ADDENDUM NO. 6

RE: Item #1, August 5, 2026 Letting - EM-P 0044(207)290, PCN 05X0, Charles Mix, Gregory County - Structure (5770'-6" Steel Girder) & Approach Grading

PLANS: Please destroy sheets E26 and E74 and replace with the enclosed sheets, dated 7/28/26 & 7/29/26.

PERMANENT CASING WELDING DETAIL

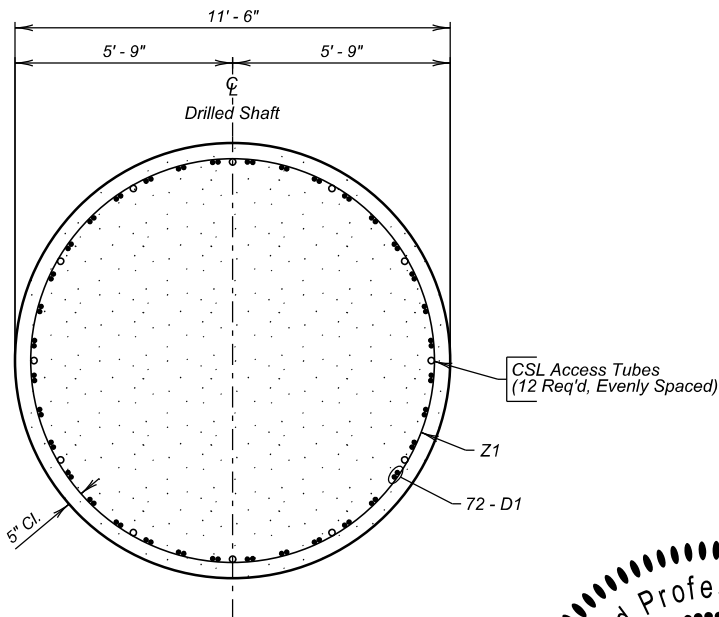
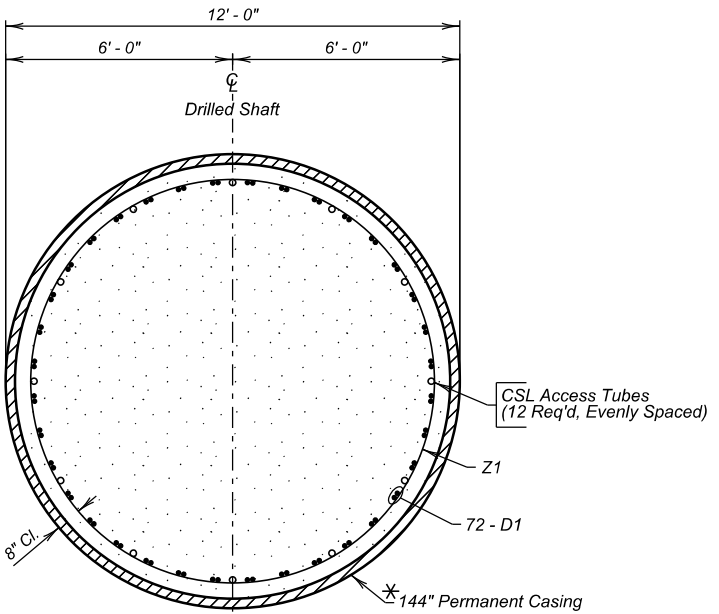
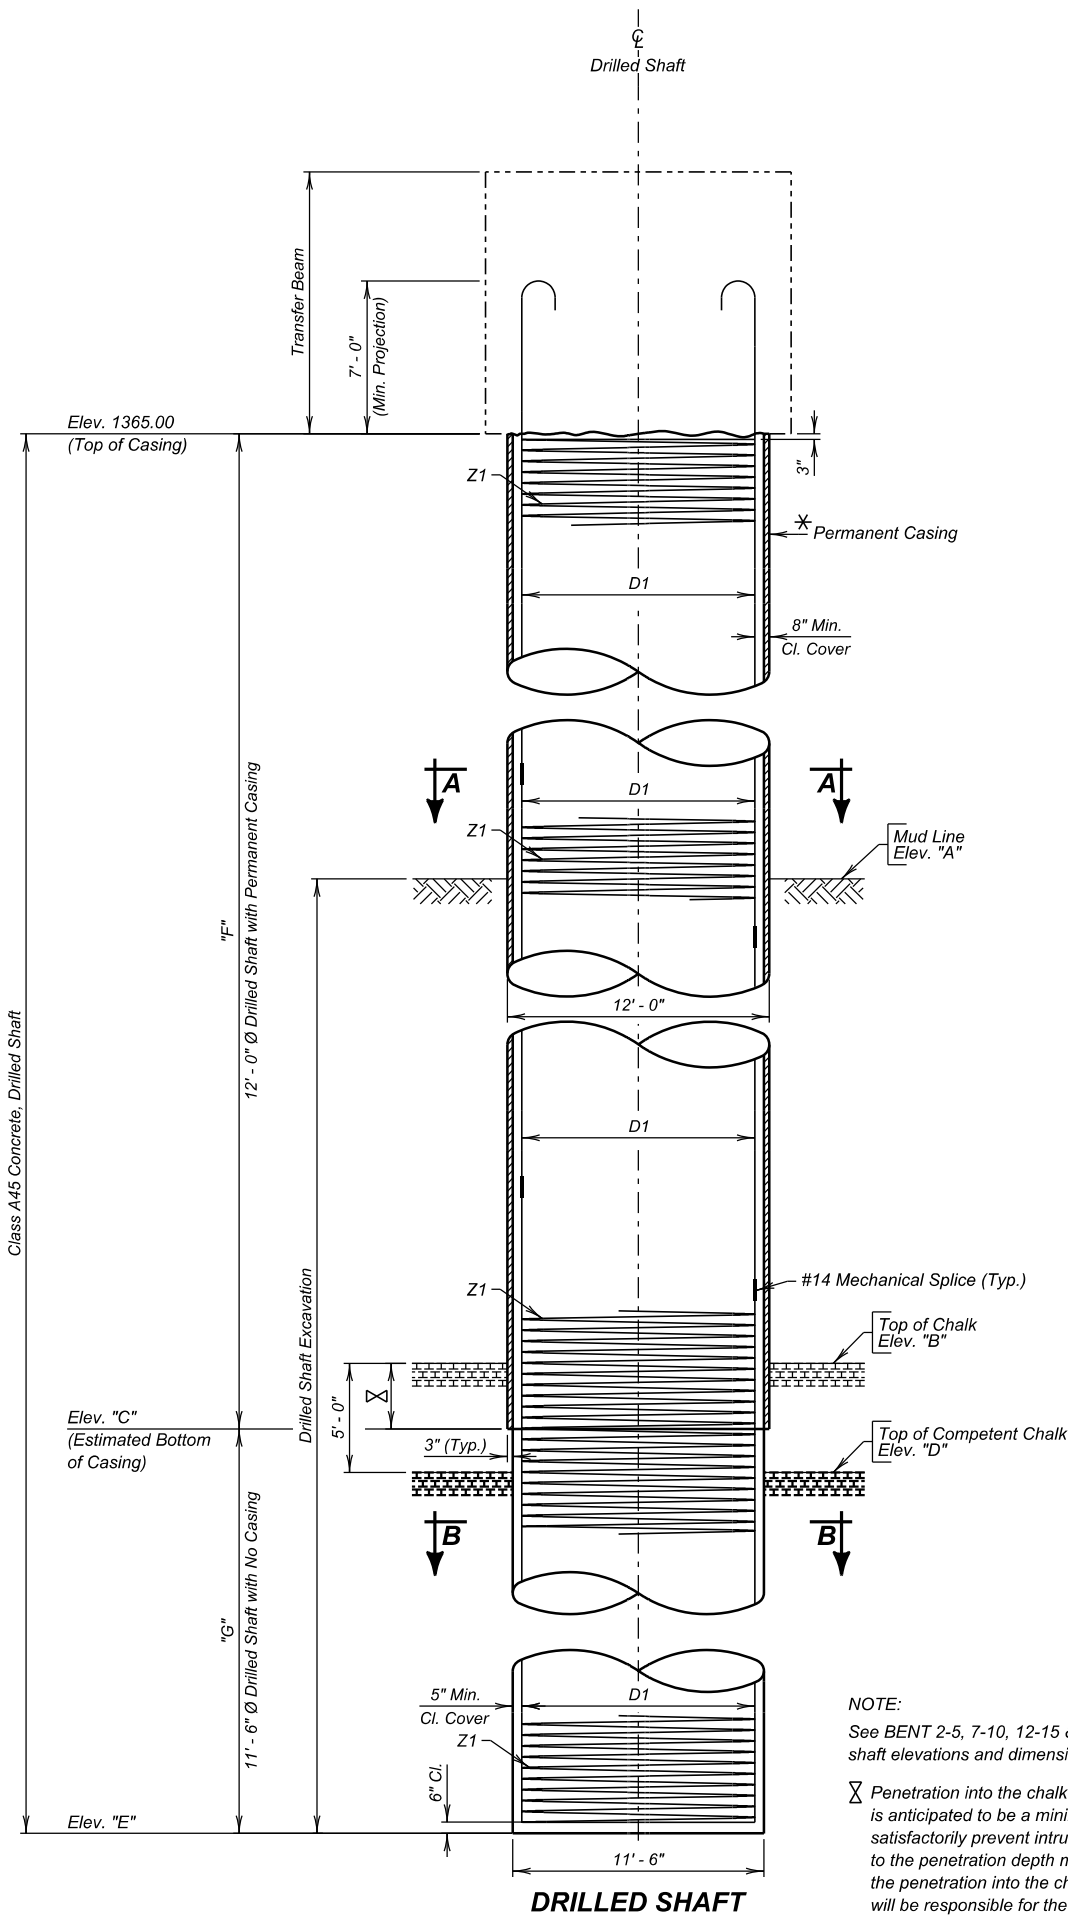
Sheet E26: PERMANENT CASING WELDING DETAIL and notes were added.

- All casing welds must be prequalified CJP groove welds.
- Welds inspection criteria:
 - 100% of welds must be visually inspected.
 - 25% of weld length must be inspected using UT.
 - AWS D1.1 must be utilized for weld and inspection requirements.
 - If more than 5% flaws are detected, then 100% of that weld seam must be inspected using UT.

SIDE ELEVATION - FIXED BENTS

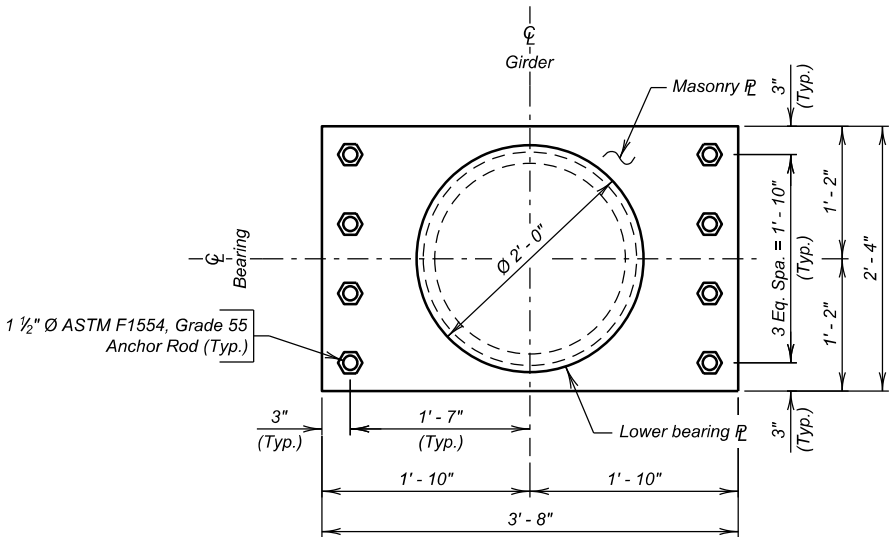
Sheet E74: Pedestal dimensions on the SIDE ELEVATION – FIXED BENTS detail were revised.
